AMENDMENTS TO THE DRAWINGS

REMARKS

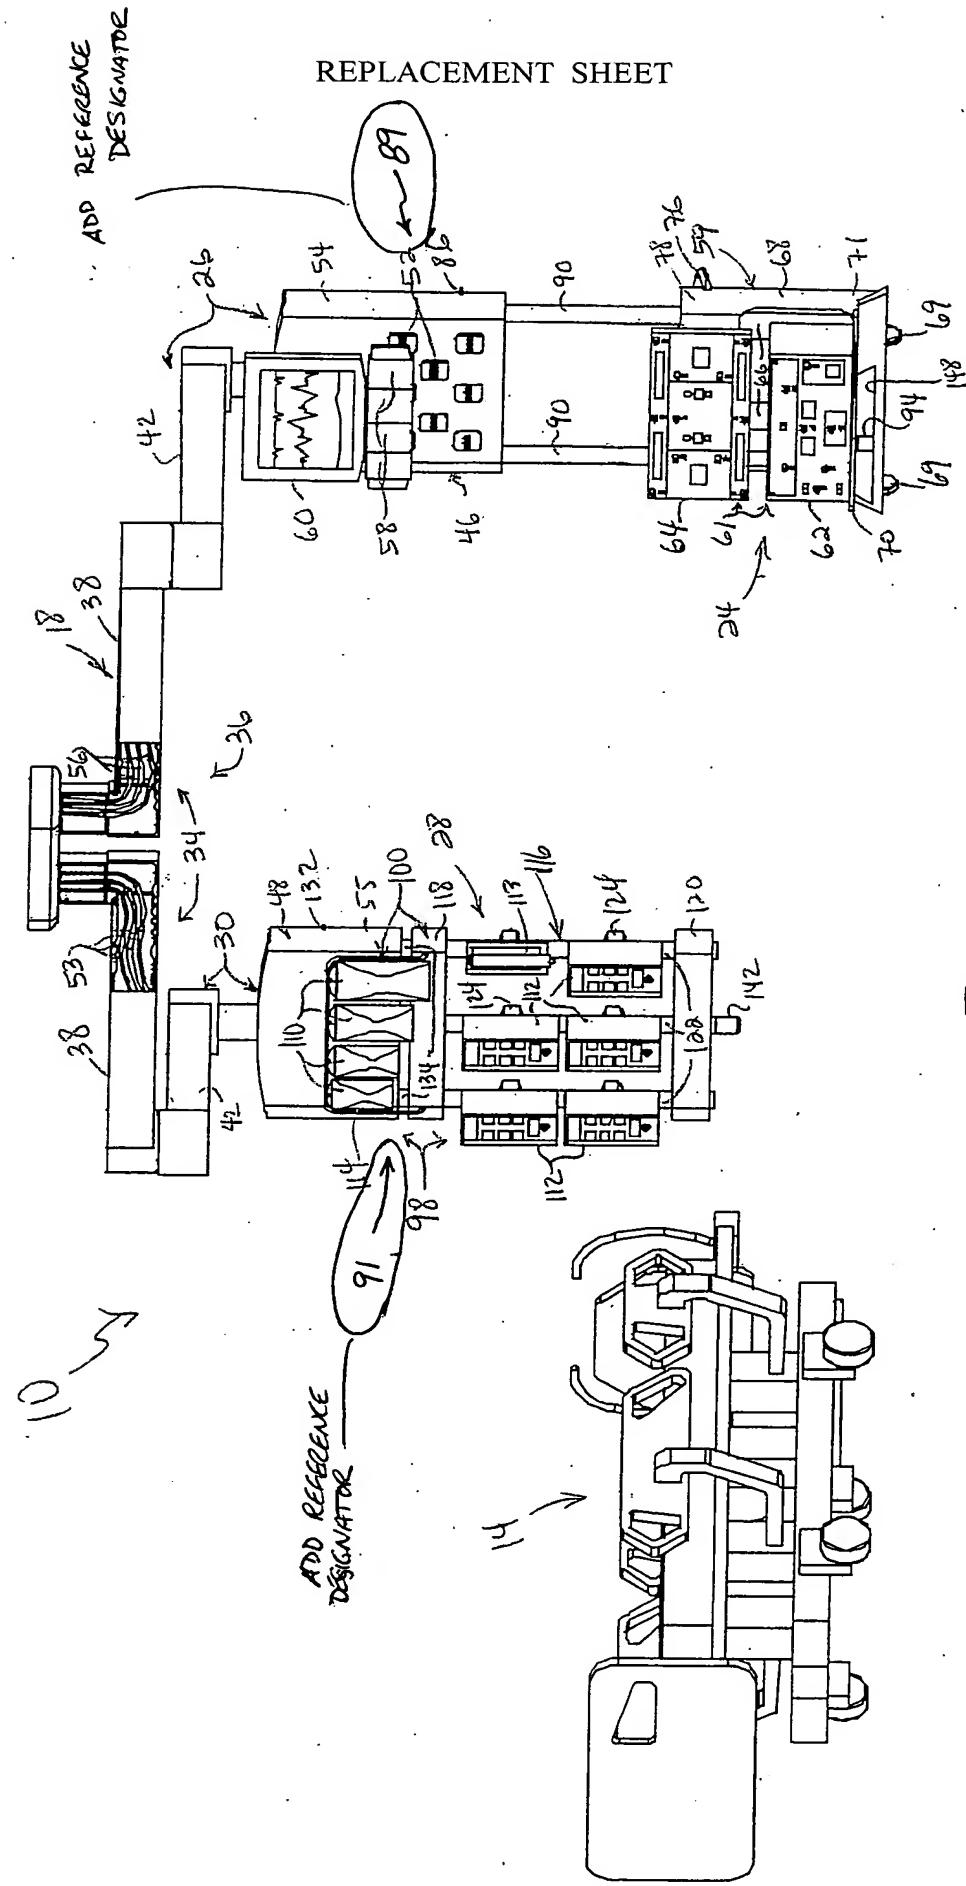
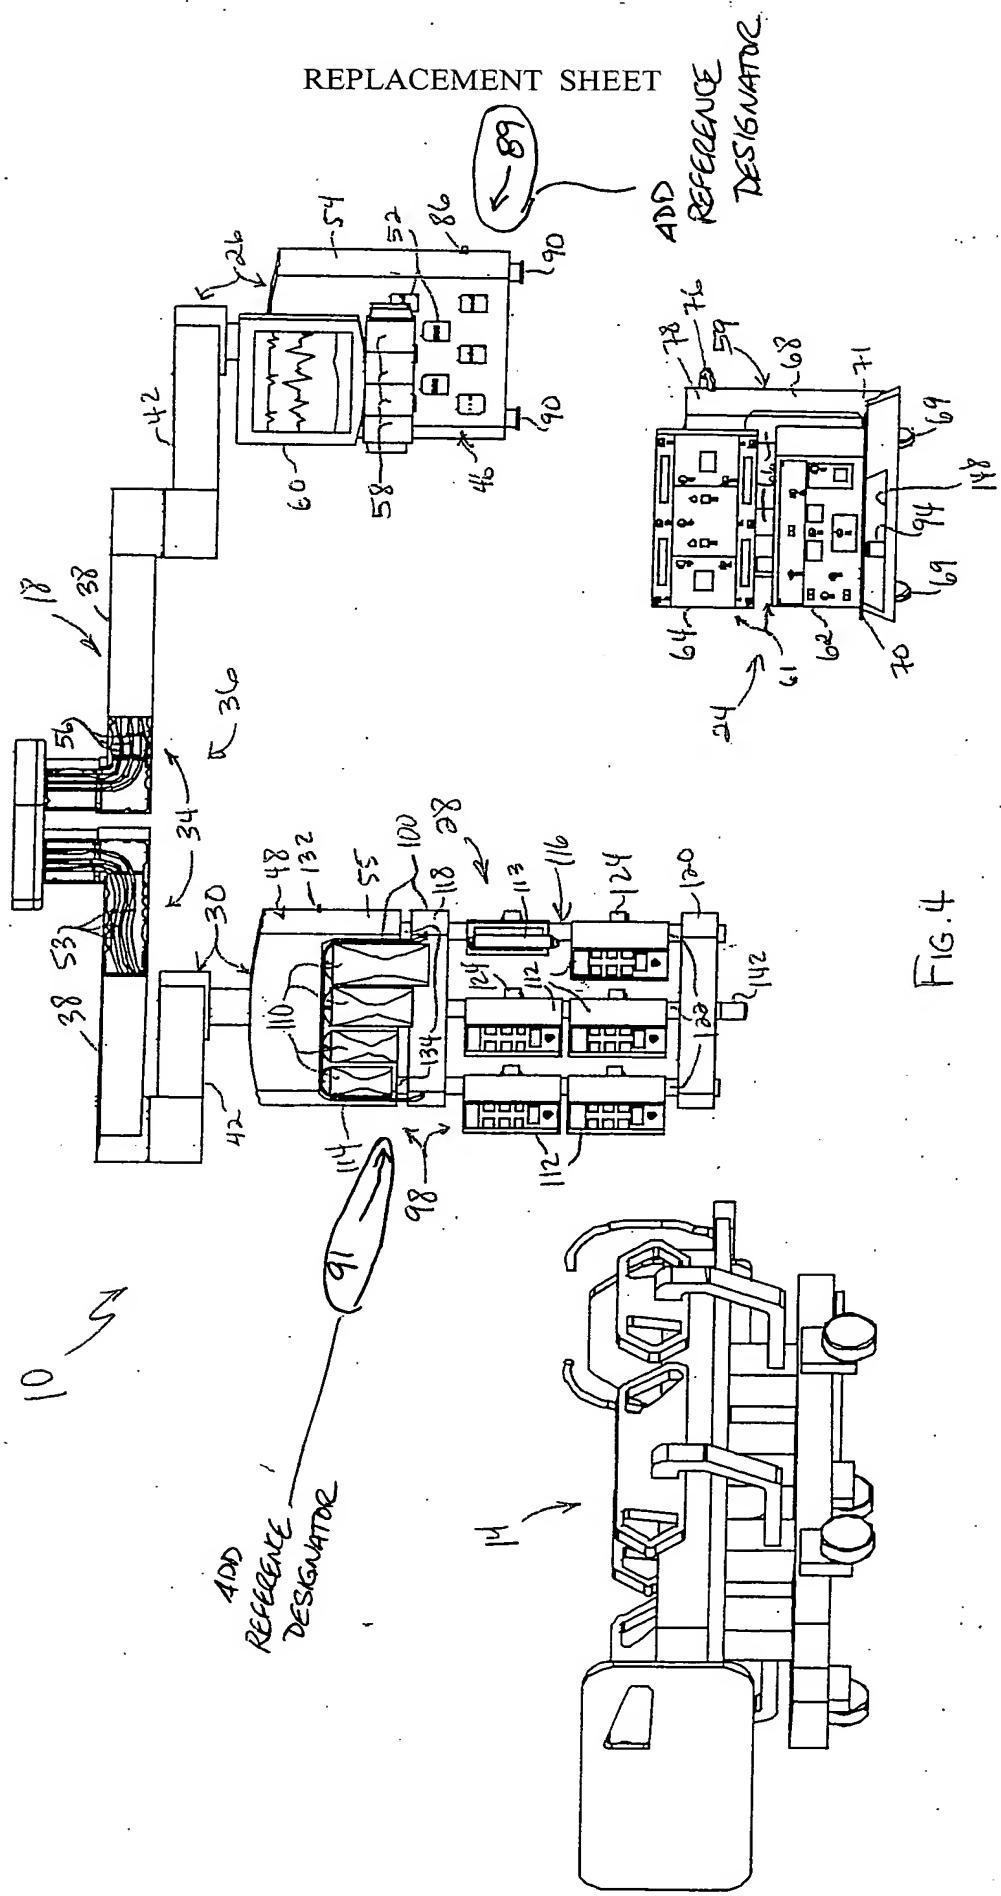
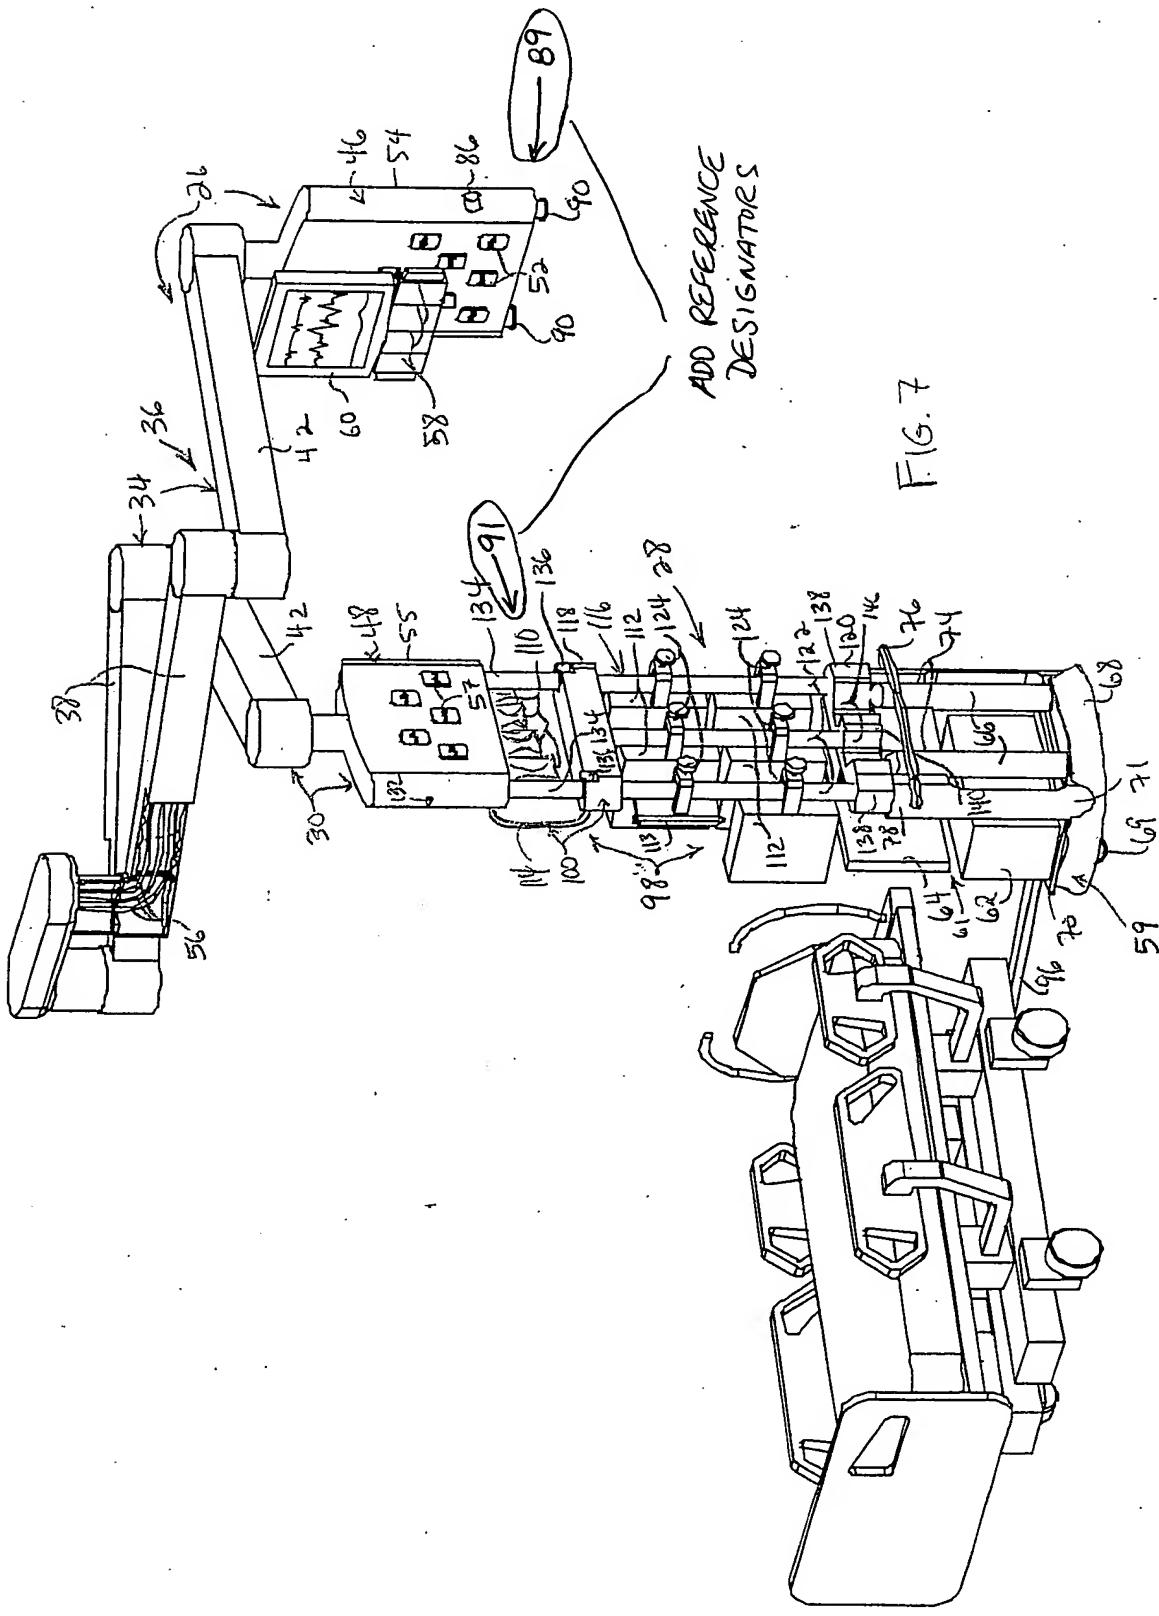
Please replace existing figures 3-4 and 7-8 with the replacement drawings attached. The figures have been amended to include reference numbers 89 and 91. Reference numbers 89 and 91 have been added by the amendments to the specification to the preexisting descriptions of the first and second lifters, respectively. No new matter has been added.

The Examiner has objected to the drawings under 35 CFR 1.83(a) for failing to show every feature of the claimed invention, namely the lifters. The lifter(s) claimed comprise multiple components shown in the figures and described in the specification. For example, “[t]he first lifter has a pair of vertically extending arms 90 (see Figs. 3-4) operable to extend and retract from housing 54 in response to operation of the first driver.” (paragraph 00038 of the Application). Also, “[t]he second lifter also has a pair of vertically extending arms 134 (see Figs. 7-8) operable to extend and retract from housing 55 in response to operation of the driver.” (paragraph 00044 of the Application.) To clarify that the lifters are illustrated in the drawings as filed, the specification and drawings have been amended to include references 89 and 91 for the first and second lifters respectively. The Applicant respectfully submits that the lifter feature is therefore adequately illustrated in the drawings as filed and one skilled in the art would understand the operation of the lifter as disclosed in the specification with reference to the drawings as filed. No new matter has been added. Thus, the objection to the drawings is believed to be overcome.
